Our Ref: JC/FR/10518

Planning Application 22 Lancaster Grove

Planning Reference 2014/2037/P

PROPOSED GROUND AND BASEMENT
22 LANCASTER GROVE
DRAWING NO: 22LGS
DATE: 2013-05-22
SCALE: 1:100 (A1): 1:200 (A3)
DRAWN BY: [Name]
CHECKED BY: [Name]
APPROVED BY: [Name]
CLIENT: [Name]
PROJECT: [Name]

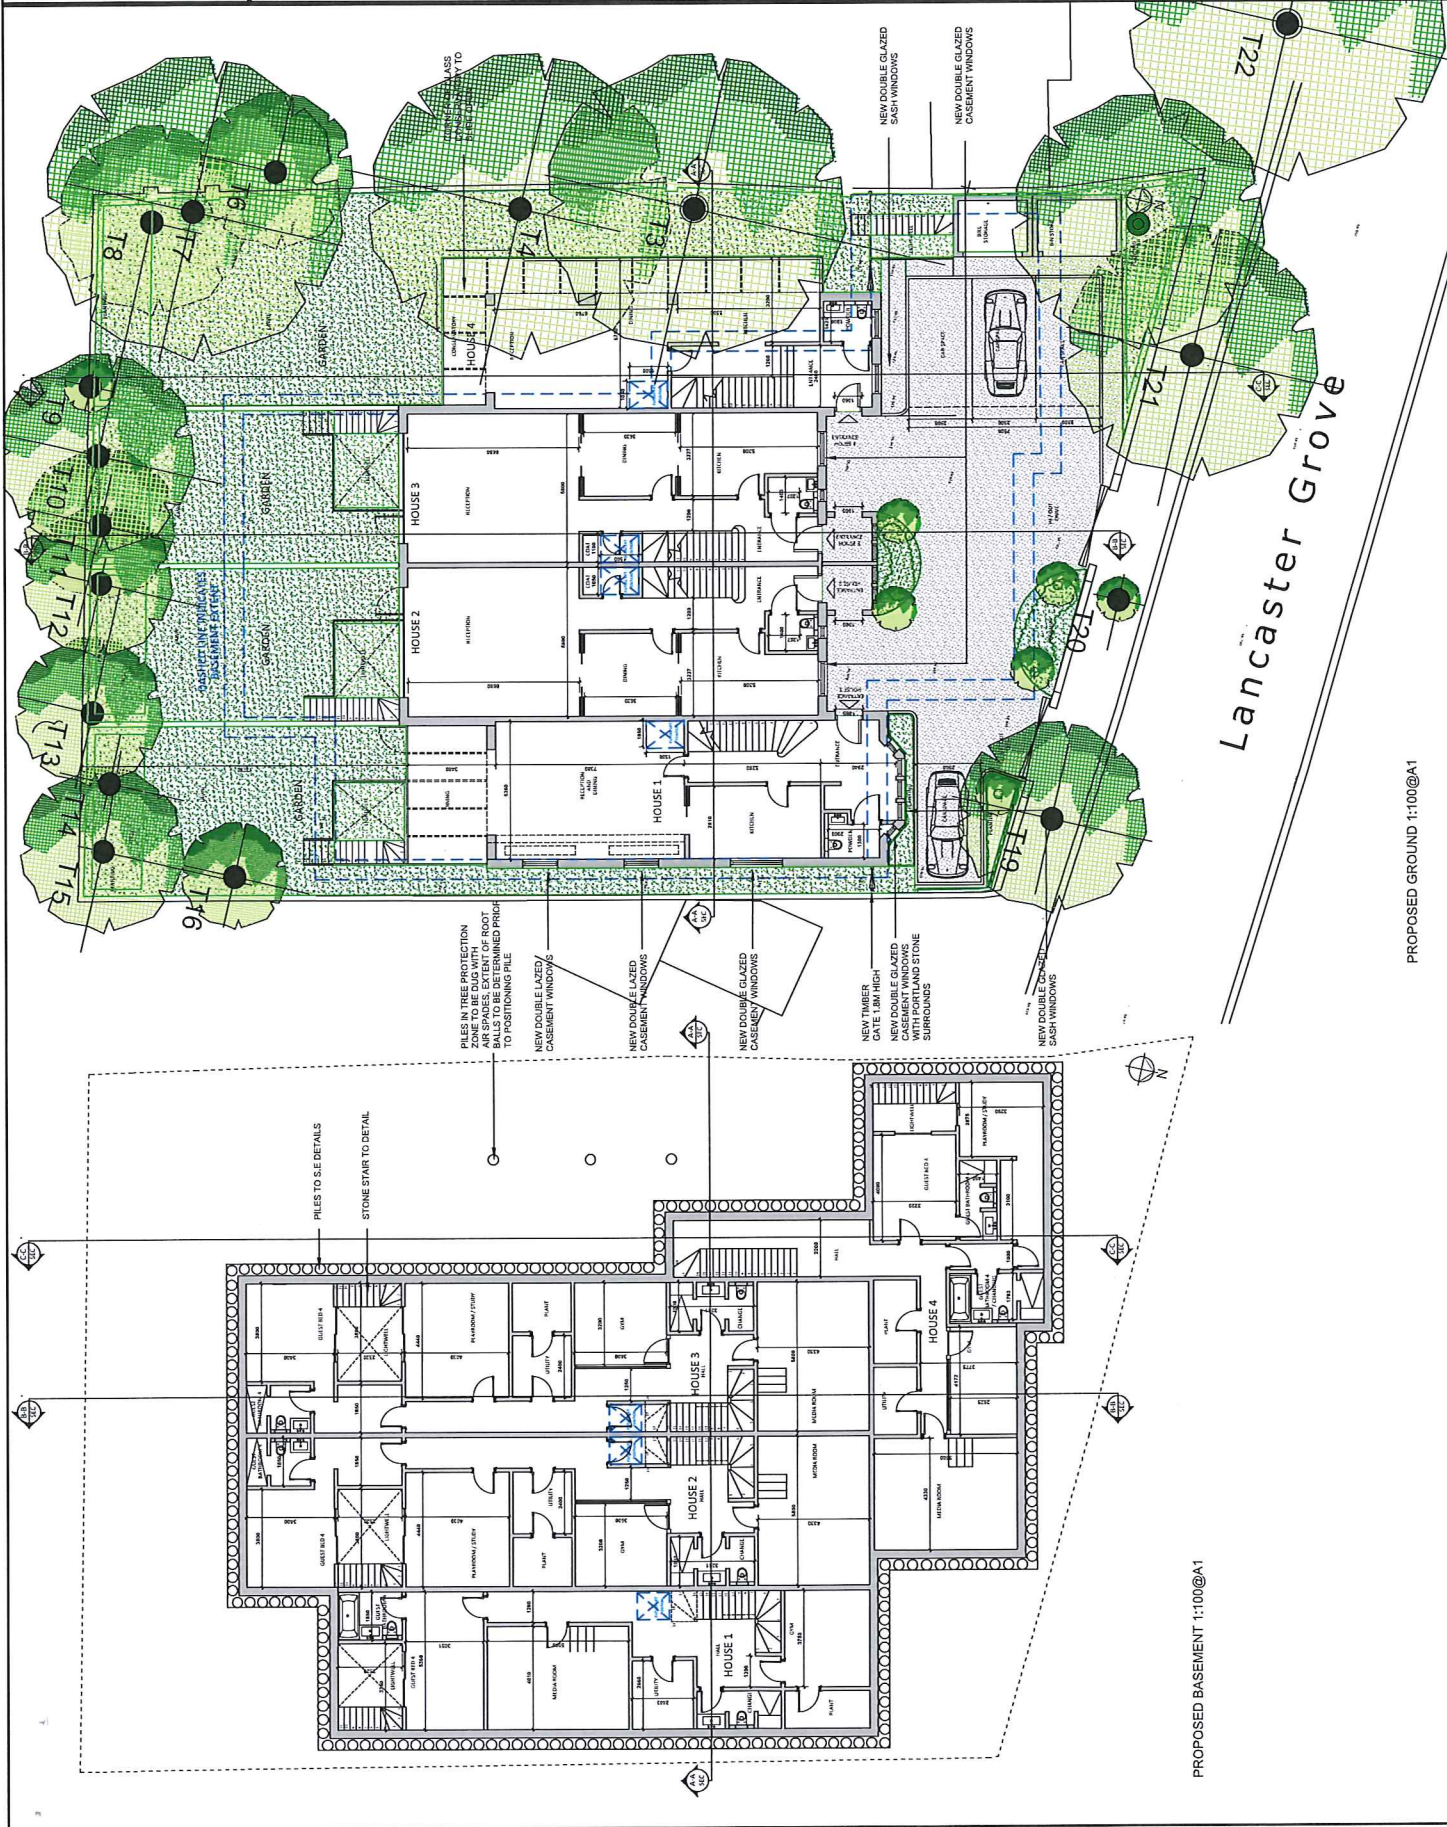
I attach drawings of the proposed ground floor and Section A-A. See **Appendix 1**. Whilst the internal floor to ceiling height of the ground floor is not intended to rise above the boundary wall, the flat roof structure would, and this would have a small effect on daylight readings where the rear (south east corner) of the ground floor will stand independently of the higher walls that rise behind the 1m setback. However, more significant is the fact that the front half of the building, with no upper floor setback, has also been excluded from the model and this would have a more noticeable effect on the readings to the flank window of the dining room which, lest it be forgotten, is the larger and primary window serving this space.

In numerical terms, this means the average Vertical Sky Component (VSC), which is 19.4% in the existing condition, reducing to 13.75% in the proposed condition as presently measured by Syntegra, would further reduce. The present figures already show the proposed value to be 71% of the existing, which BRE define as an adverse effect, but I conclude is worse than that stated.

Фото 2

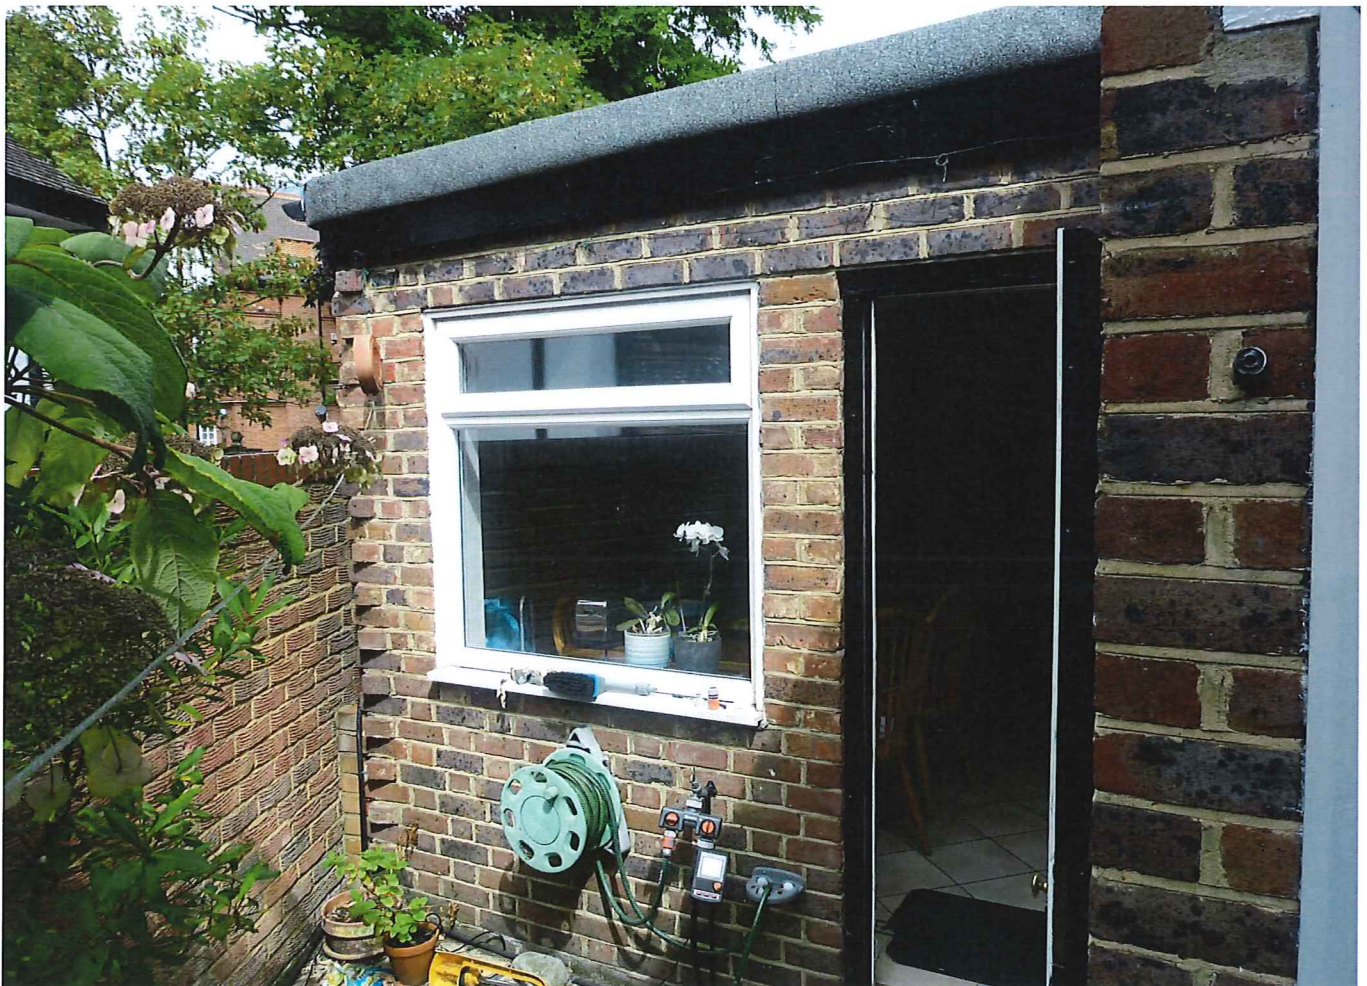
Continuing with the dining room windows. Even the revised graphics for the second window to this room show a window that is significantly larger than the window in situ and I attach a photograph to confirm this. See **Appendix 2**.

- (g) I remain unconvinced the model has been revised to reflect the true location of the breakfast room serving 24 Lancaster Grove. The graphics on pages 4, 6 and 7 all show a gap between this room and the boundary wall. This does not exist, as confirmed by the attached Photograph 2, **Appendix 2**. In consequence, it is difficult to accept the window is correctly located in relation to the existing built environment and proposed built environment. The revised figures confirm a reduction from existing VSC to proposed VSC of 27% to 21.25%, a ratio of 80%. This is touching on an adverse impact and for the reasons I have outlined in items (f) and (g), could in fact be an adverse impact.

The rear elevation creates an even greater distortion. This again suggests the two buildings stand parallel to one another, but the location plan shows they do not. Photograph 3 clearly shows the boundary line cuts across the face of the breakfast room window, whereas the drawing of the rear elevation suggests the boundary and the proposed building, both stand well clear of this window.
